Staff Report: PHO-2-22--Z-47-17-8

APPLICATION #: PHO-2-22--Z-47-17-8

REQUEST:
1) Modification of Stipulation 1 regarding general conformance with the site plan date stamped July 28, 2017.
2) Review of conceptual elevations by the Planning Hearing Officer per Stipulation 4.

Proposed Site Plan

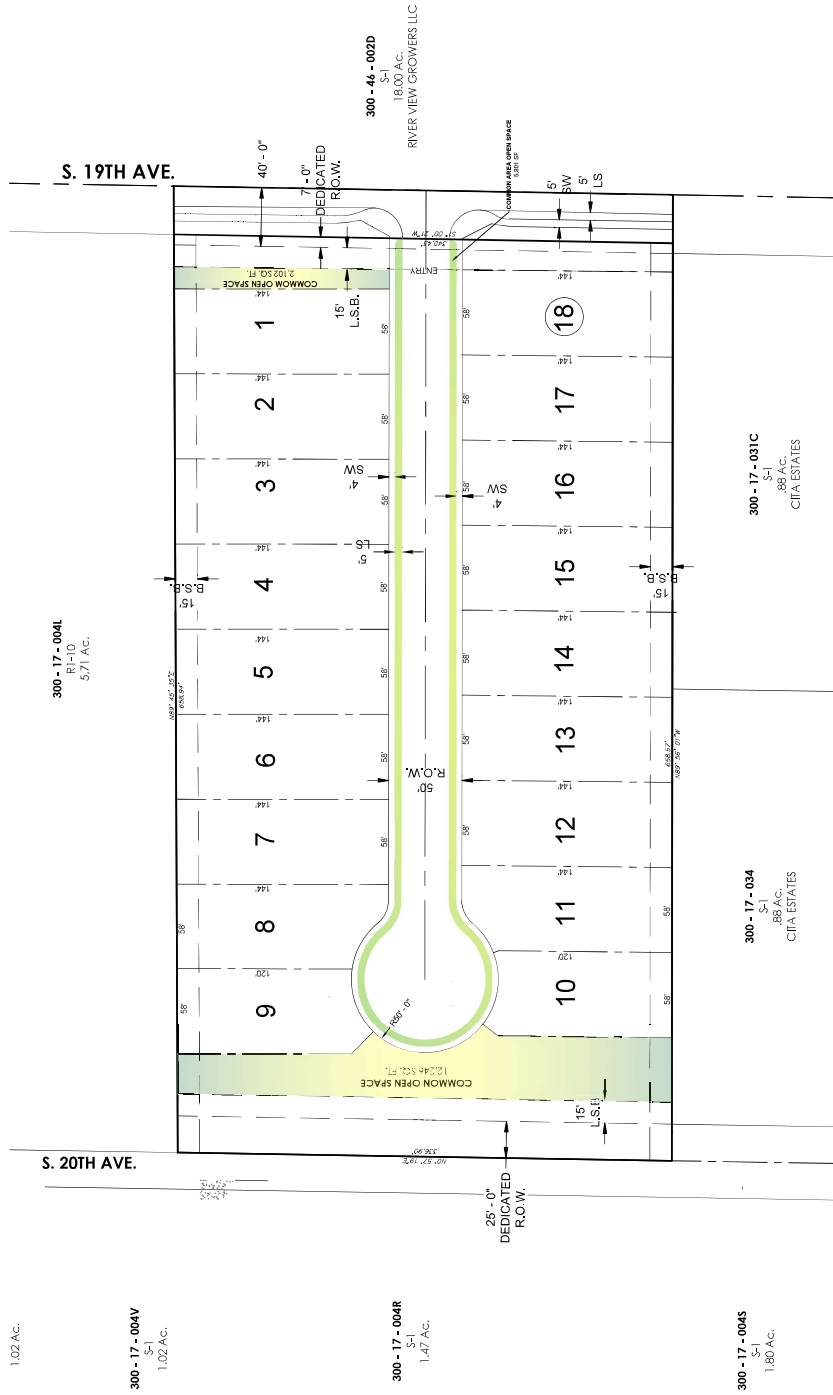
The proposed conceptual site plan depicts an 18-unit single-family subdivision at approximately 3.51 dwelling units per gross acre, with approximately 9% open space. Units are arranged along a street running east/west through the site. The street terminates in a cul-de-sac along the west property line. Most of the open space is along the west property line. The proposal is substantially similar to the stipulated site plan, with the caveat that it is designed with less than half of the original area. The density remains below, and the open space above, Ordinance standards. The proposal is compatible with existing development in the surrounding area.

A new sub-stipulation is recommended requiring staggered front setbacks. This recommendation is consistent with the recommendation of the South Mountain Village Planning Committee. It is also consistent with design recommendations in the Rio Montaña Area Plan (Page 39, Figure 71).

Mr. Stranieri provided an overview of the proposed conceptual site plan and stated that the density depicted consists of approximately two more units than what would be permitted using the density shown on the stipulated site plan. He stated that the change is modest and remains below the maximum permitted density in the R1-10 zoning district. He stated that approximately 9% open space is depicted on the proposed conceptual site plan, which is approximately twice the minimum open space required by the Zoning Ordinance. He stated that a technical appeal may be required regarding the termination of the cul-de-sac on the west portion of the site. Scott Lucas, representative with Terrascope

1.	The development shall be in general conformance with the site plan date stamped JUNE 30, 2022 July 28, 2017 , as modified by the following stipulations and approved by the Planning and Development Department, WITH SPECIFIC REGARD TO THE FOLLOWING:
A.	THE SITE PLAN SHALL DEPICT STAGGERED FRONT SETBACKS FOR COVERED BUILDING ELEMENTS, SUCH THAT ANY TWO ADJACENT LOTS SHALL PROVIDE A MINIMUM VARIATION IN FRONT SETBACK OF 4 FEET.

EXHIBIT I

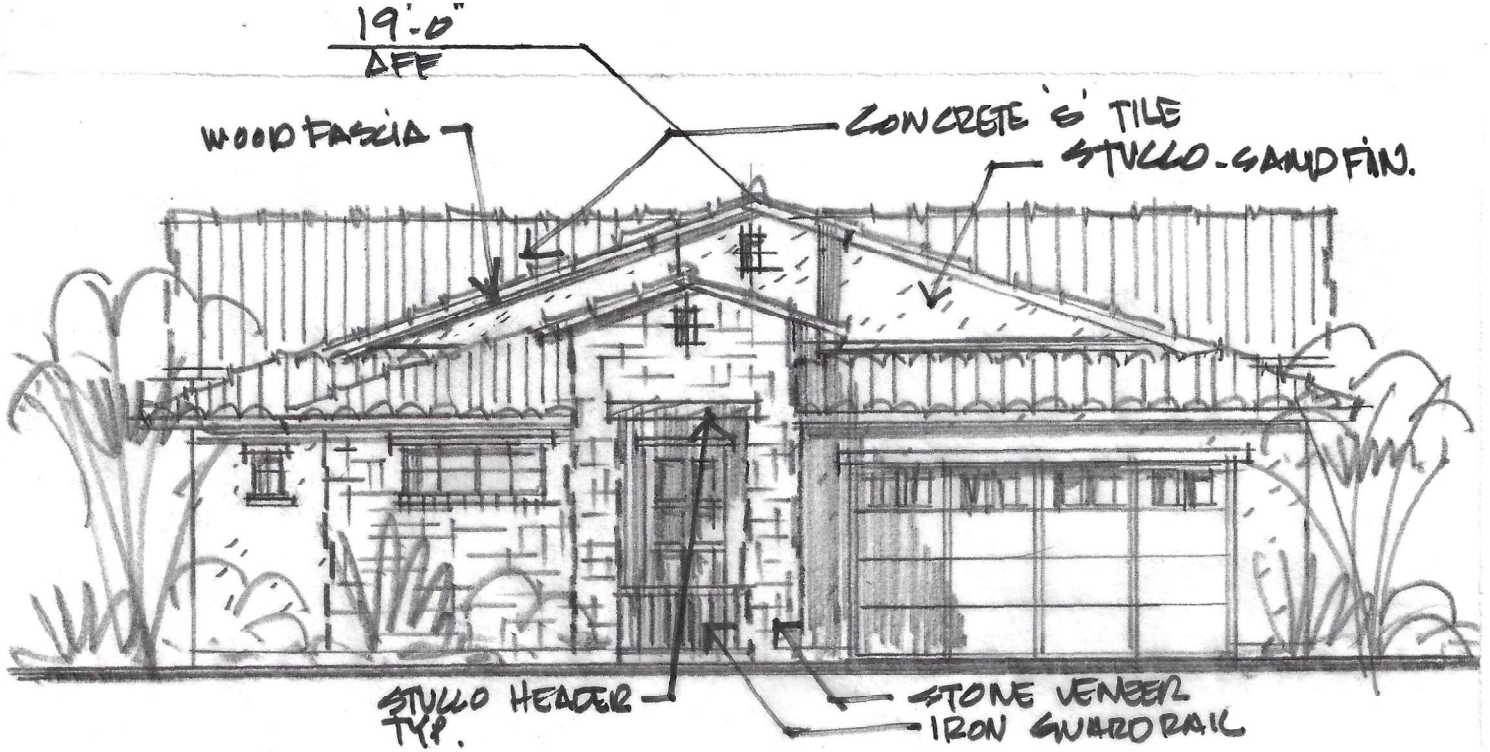
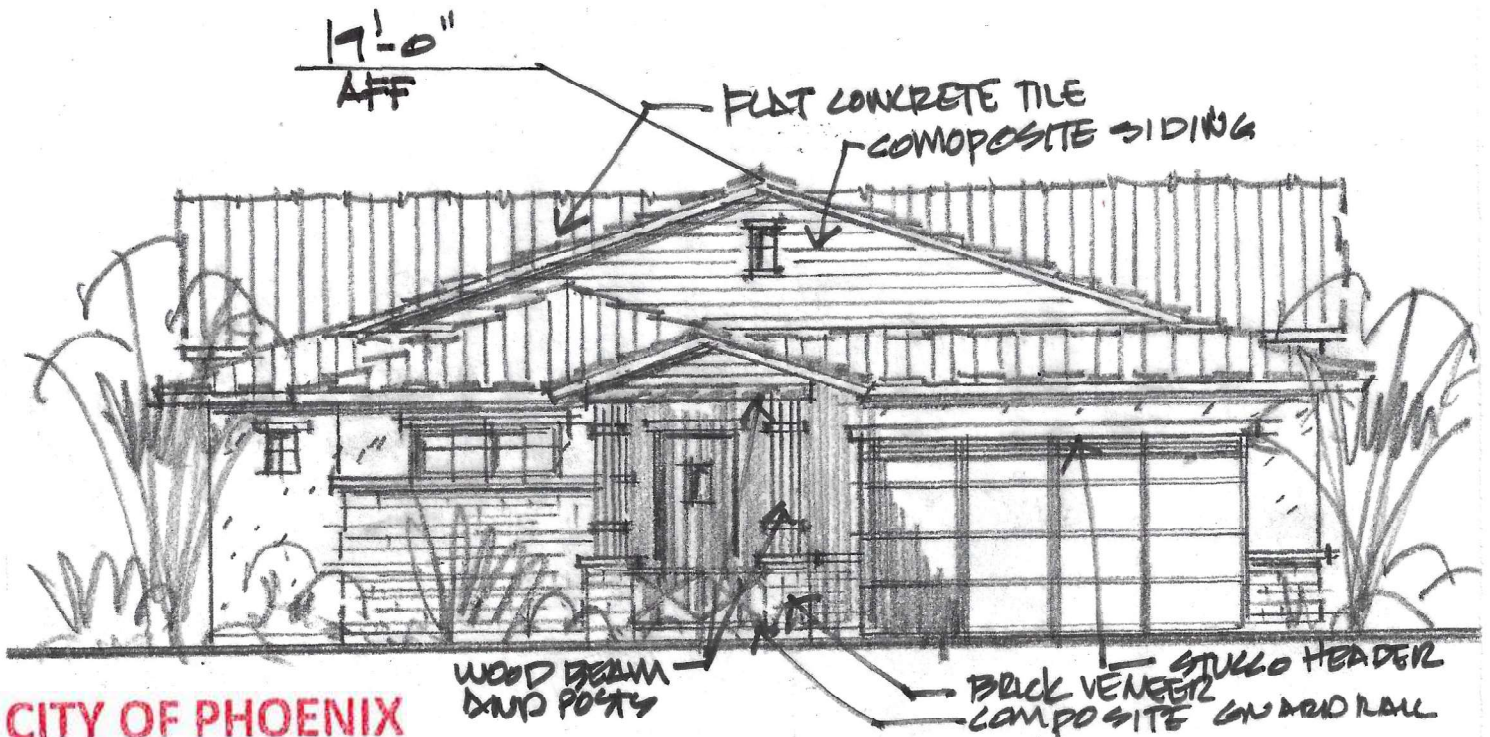
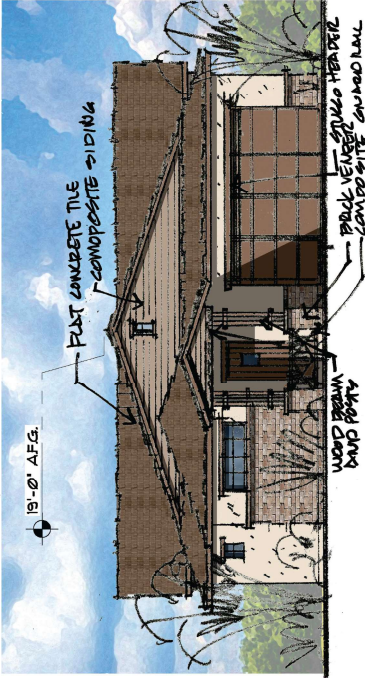
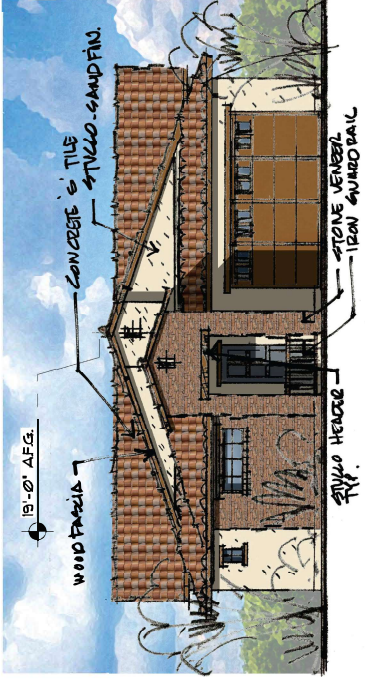
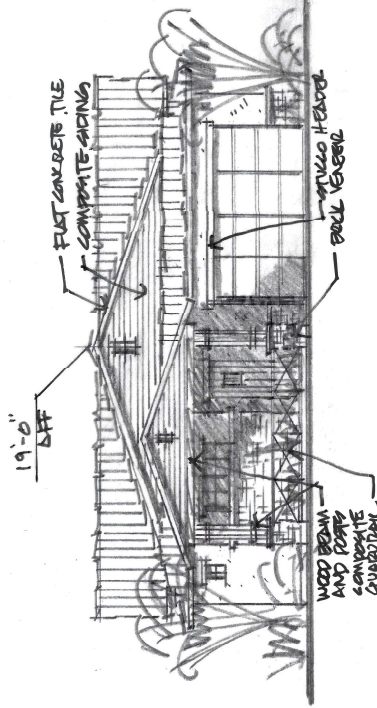
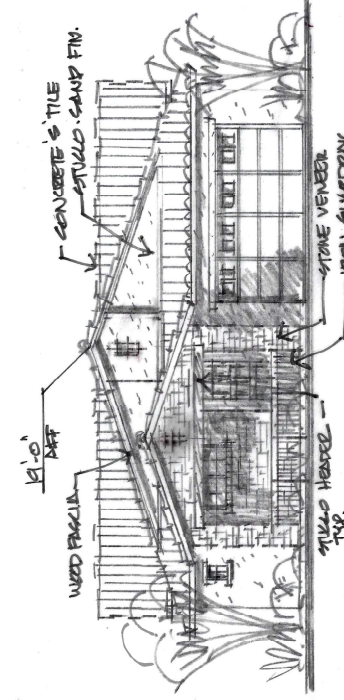
- 3) The applicant submitted conceptual elevations for review and approval per the requirements of Stipulation 4. The stipulation has been complied with and is recommended to be deleted and replaced with a standard language stipulation for general conformance to the elevations provided. Stipulation 4 states that the elevations submitted should be consistent with recommendations in the Rio Montaña Area Plan. The elevations depict a variety of building materials (stone façade, composite siding, wood elements, brick veneer), multiple building colors, variation in roof design, and multiple architectural features (wood posts, gable ornamentation, varied window sizes, decorative garage panels). This diversity is

consistent with the Rio Montaña Area Plan and many of the design choices are compatible with the rural and agricultural character described in the plan.

Mr. Valencia presented the elevations while bringing out that some key areas include reduction of garage dominance which could be done by stepping back the garage which all the elevations seem to indicate. Mr. Valencia stated that side loaded garages are closer to the front property line but break up garage dominance because it has windows and acts like a faux front. Mr. Valencia stated that none of the elevations indicate side loaded garages so of the committee wants that they will have to give some specifics such as percentage of elevations to provide that option. Mr. Valencia next mentioned front porches are also characteristic of the Rio Montaña Area Plan and that all the proposed elevations do not indicate porches or their dimensions. All elevations indicate pitched roofs which Mr. Valencia said was another Rio Montaña Area Plan character trait. As well as the variety of materials being proposed.

Kevin Zenk mentioned that side loaded garages would be difficult to achieve on lots of this width because of turning radius requirements. Mr. Zenk added that they are accepting of the front porch requirements as it does create more massing and reduces the prominence of the garage. **Chair Daniels** replied that she has seen smaller lots with side loaded garages.

- 1) The lots in the subdivision shall be staggered.
- 2) 75 percent of the elevations shall provide covered porches. Porches shall be consistent with recommendations in the Rio Montaña Area plan and provide a minimum of six-foot depth and a minimum sixty square feet in area.

5.	COVERED PORCHES A MINIMUM OF SIXTY SQUARE FEET IN AREA AT A DEPTH OF AT LEAST SIX FEET SHALL BE PROVIDED IN THE FRONT YARD OF FIFTY PERCENT OF THE HOMES IN A SUBDIVISION. NO PORCH SHALL TERMINATE WITHIN THE PLANE OF A DOOR OR WINDOW.
